The Sizewell C Project

2.8 Two Village Bypass Plans For Approval

July 2021

Two Village Bypass Plans For Approval – Revisions Schedule

DRAWING TITLE:
TWO VILLAGE BYPASS
SITE CLEARANCE PLAN
SHEET 2 OF 2

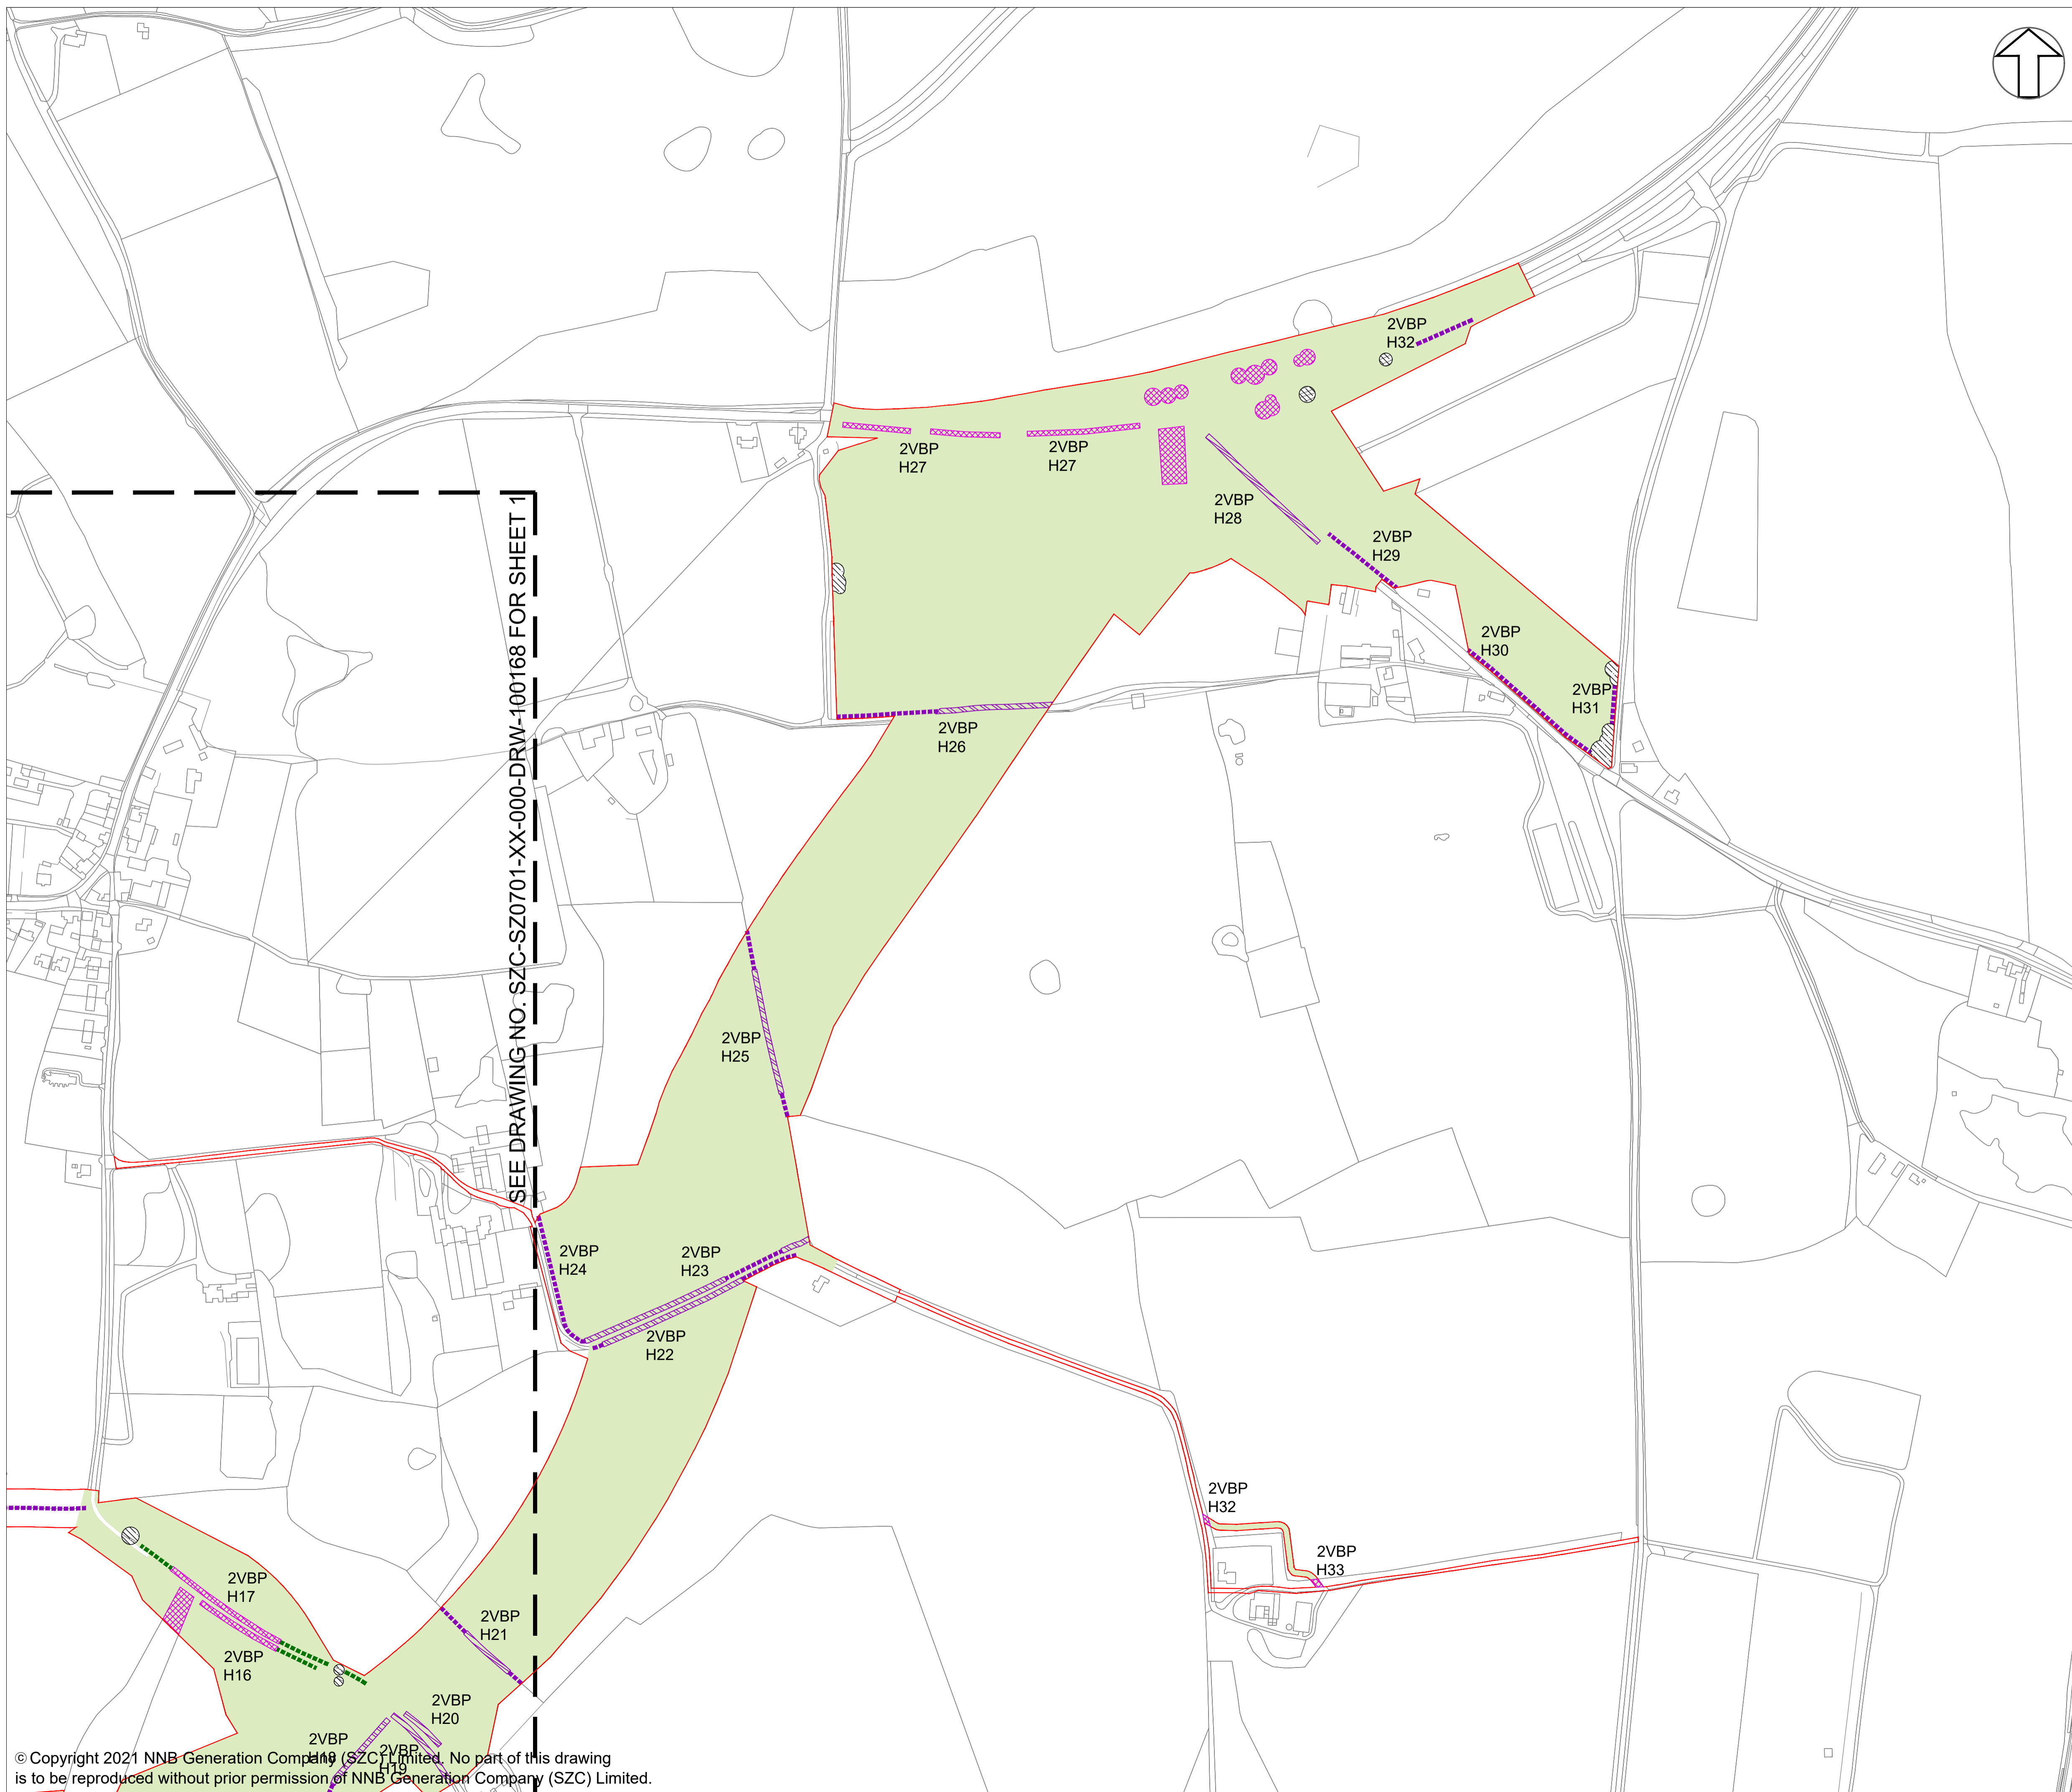
SZC-SZ0701-XX-000-DRW-100169	03	Two Village Bypass Site Clearance Plan - Sheet 2 of 2	Retention of 8m hedgerow to the south of the existing path at Farnham Hall
